WATERSIDE SHOPS
5455 TAMIAMI TRL N SUITE #B-7
NAPLES, FL 34108

TENANT	ABBREVIATIONS	SEPARATE PERMITS	PROJECT SCOPE OF WORK	LANDLORD NOTES	PROJECT SITE	SHEET		
TRISH WESCOAT POUND 318 W 39TH ST. SUITE 300 NEW YORK, NY 10018	ADJ. ADJACENT A.F.C. ABOVE FINISHED CEILING A.F.F. ABOVE FINISHED FLOOR A.C.T. ACOUSTICAL CEILING TILE ADA AMERICANS WITH DISABILITIES ACT ADAAG ADA ACCESSIBILITY GUIDELINES AIA AMERICAN INSTITUTE OF ARCHITECTS AIEE AMERICAN INSTITUTE OF ELECTRICAL ENG. AISC AMERICAN INSTITUTE OF STEEL CONSTRUCTION ALT. ALTERNATE ARCH. ARCHITECT BD. BOARD BLK. BLOCKING BM. BEAM B.O. BY OTHERS BOT. BOTTOM BTU BRITISH THERMAL UNIT CL. CENTERLINE CAB. CABINET C.H. CEILING HEIGHT CLR. CLEAR CLG. CEILING CLKG. CAULKING CNTR. COUNTER CNT. CENTER CONC. CONCRETE COL. COLUMN C.W. CENTER OF WALL CPT. CARPET CONT. CONTINUOUS CONSTR. CONSTRUCTION C.G. CORNER GUARD CMU CONCRETE MASONRY UNIT DEMO. DEMOLITION DWG. DRAWING DIA. DIAMETER DN. DOWN DR. DOOR ELEC. ELECTRICAL E.P. ELECTRICAL PANELBOARD EMER. EMERGENCY EQ. EQUAL EQUIP. EQUIPMENT EWC. ELECTRIC WATER COOLER (E). EXG. EXISTING EXH. EXHAUST EA. EACH EXT. EXTERIOR FBO. FURNISHED BY OWNER F.C. FIXTURE CONTRACTOR F.F. FINISH FLOOR F.D. FIRE

ELECTRICAL LIGHTING PLAN - MEZZANINE

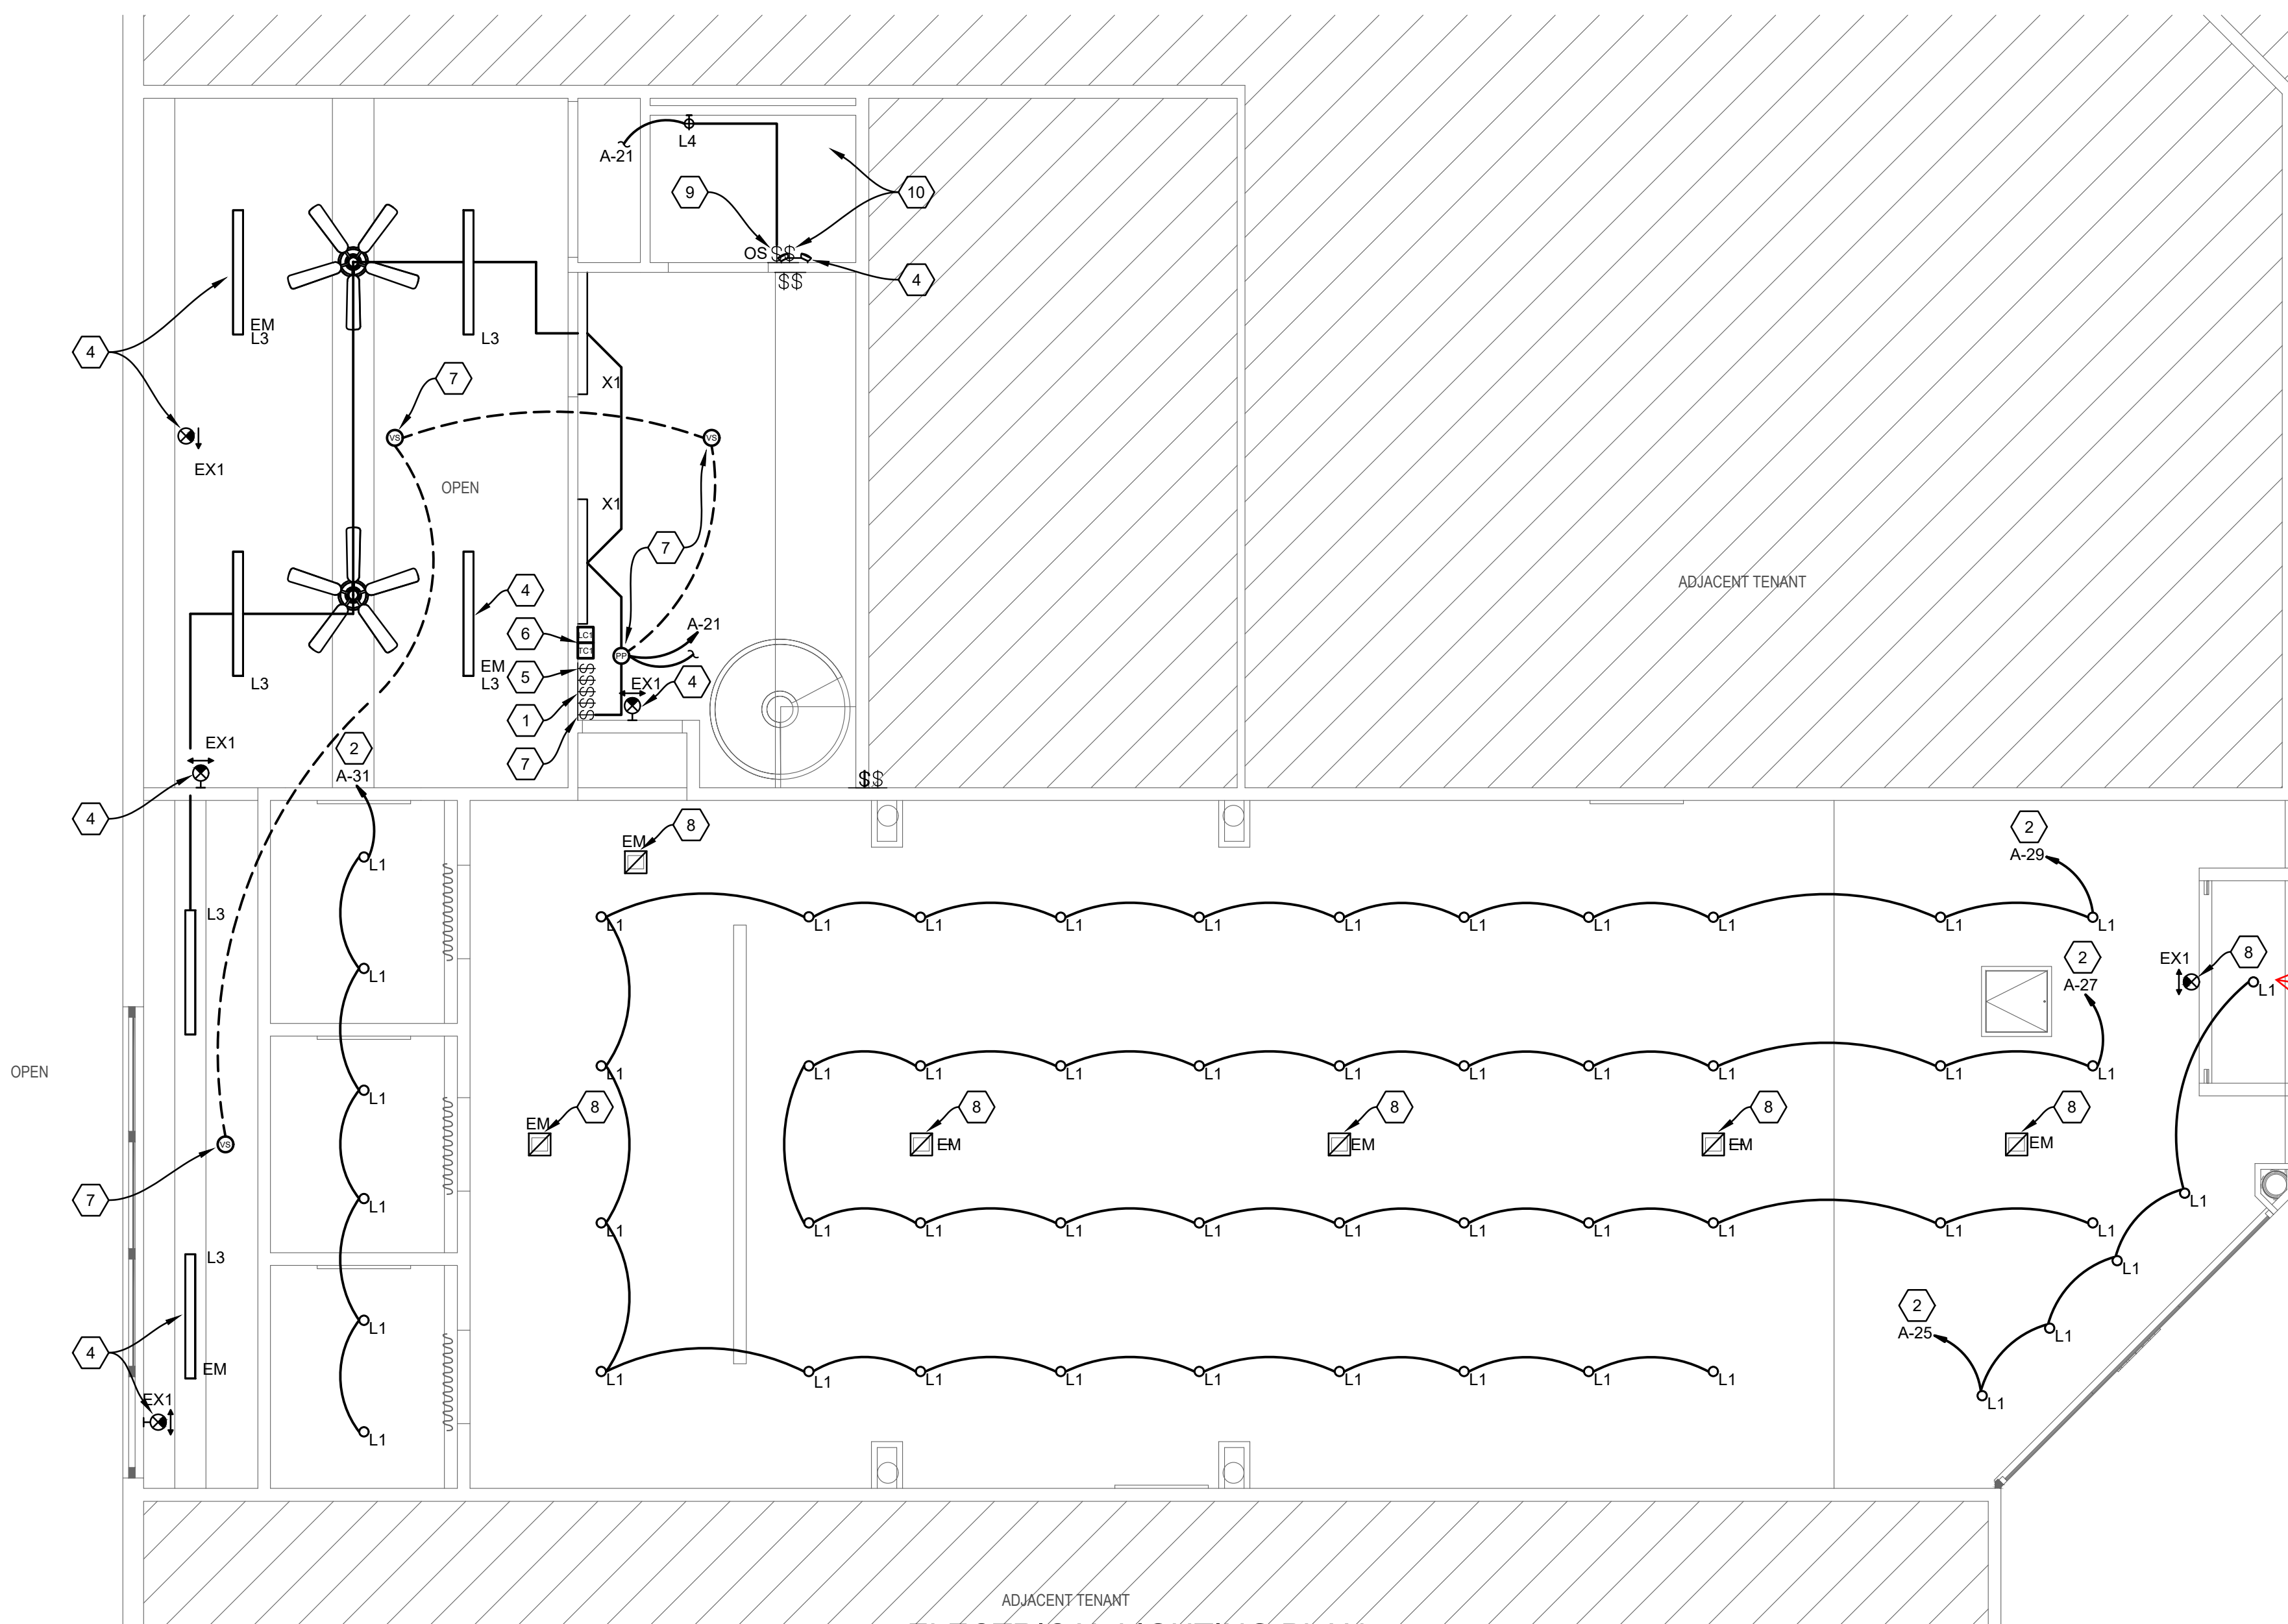
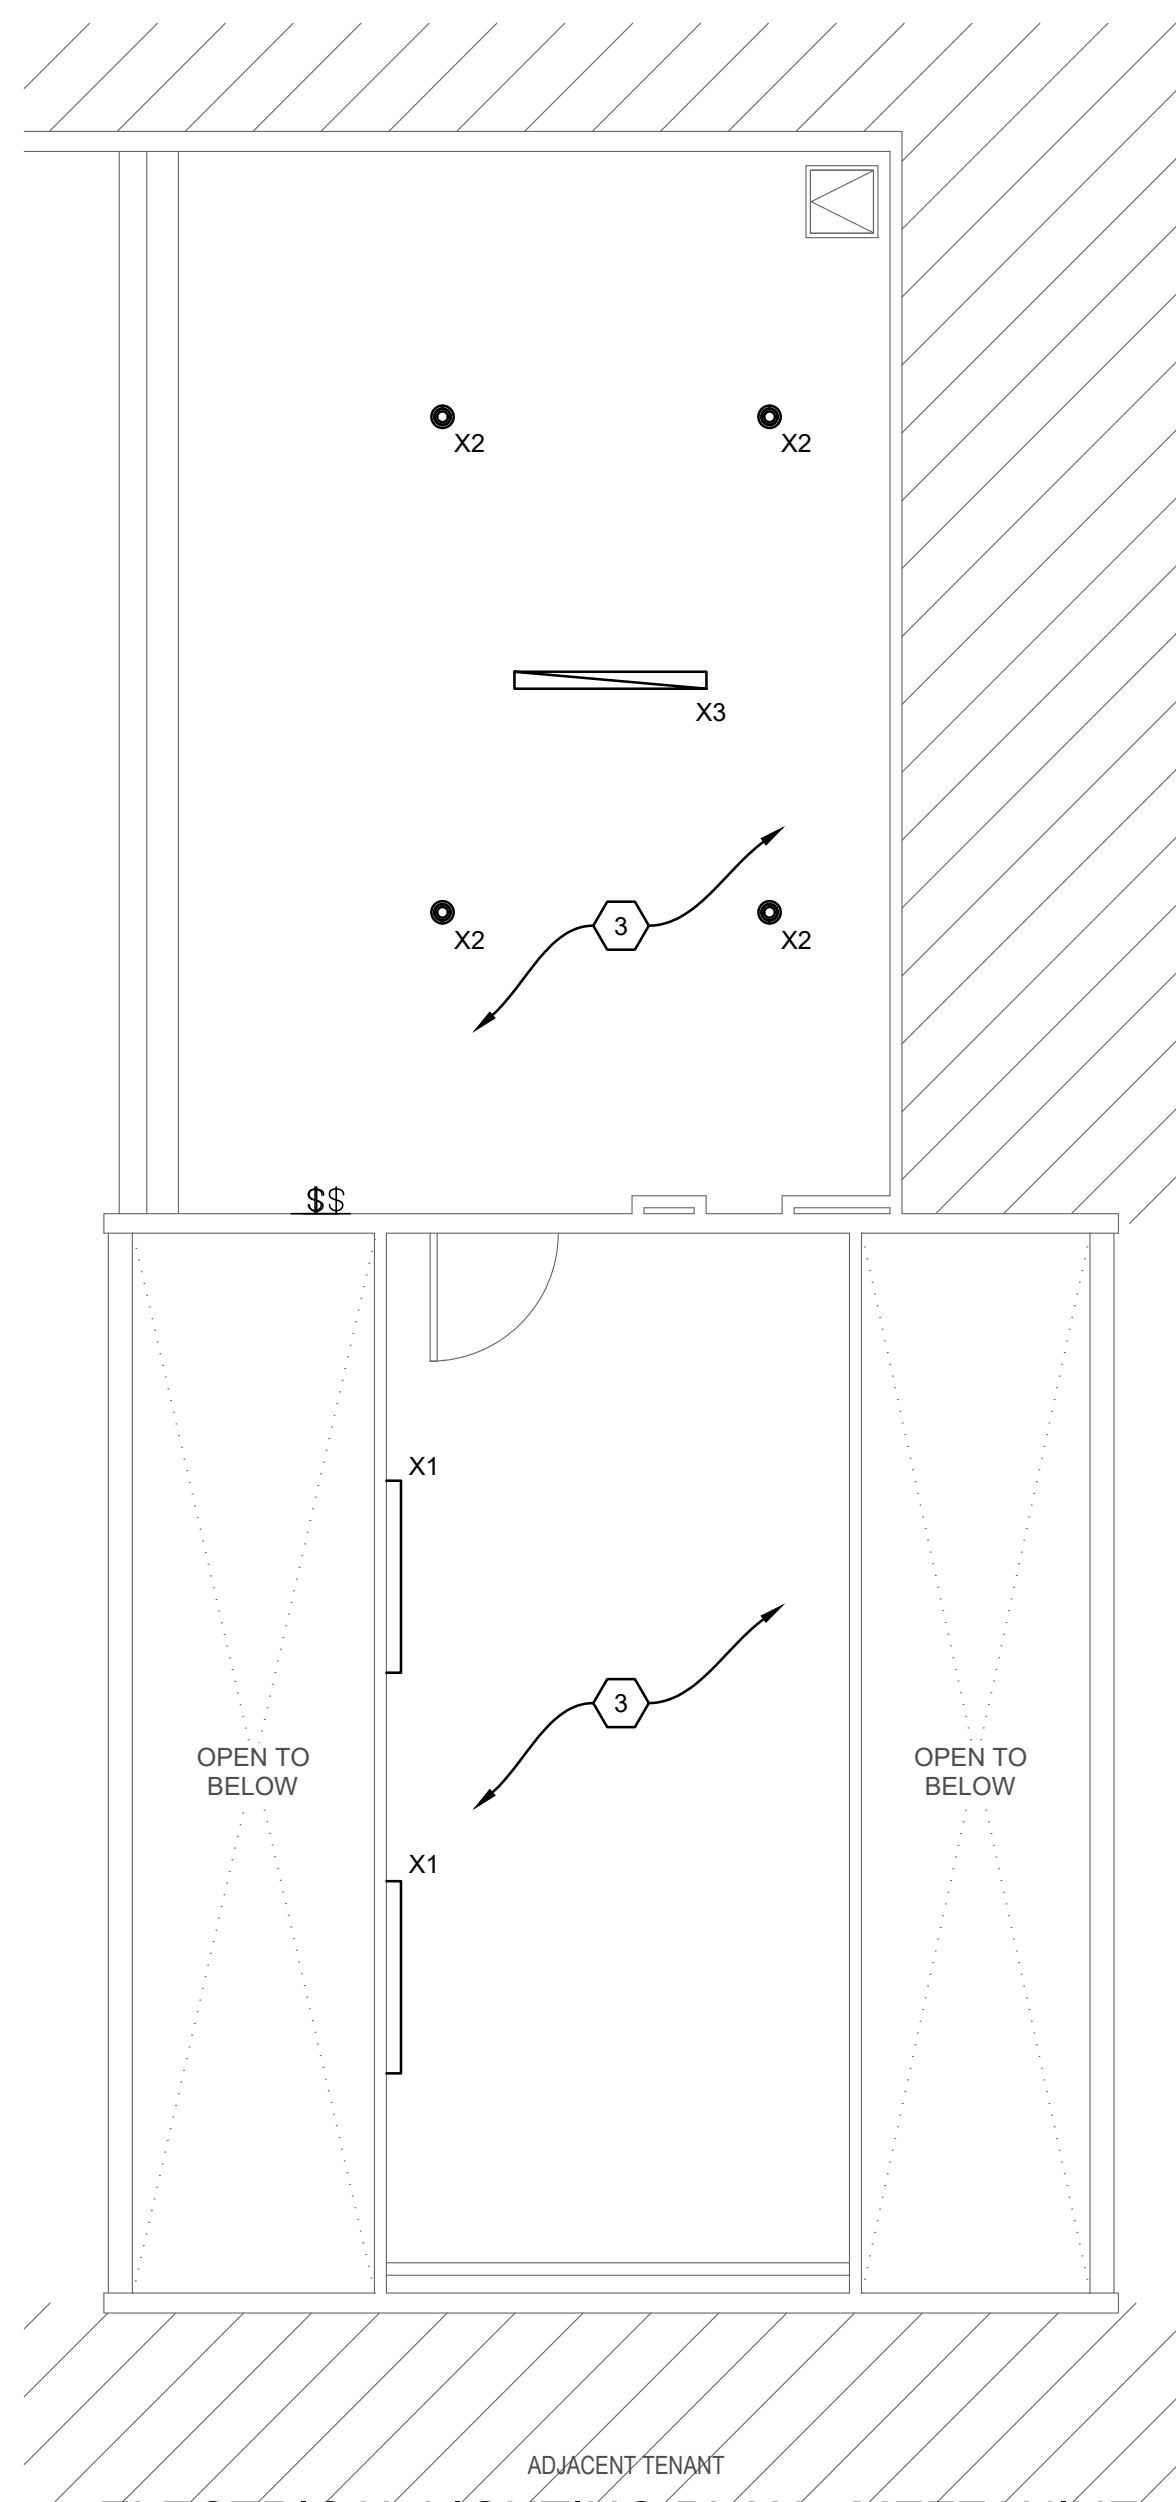
needs to be a outdoor rated light if we are adding a downlight. need spec and should match finishes outside.
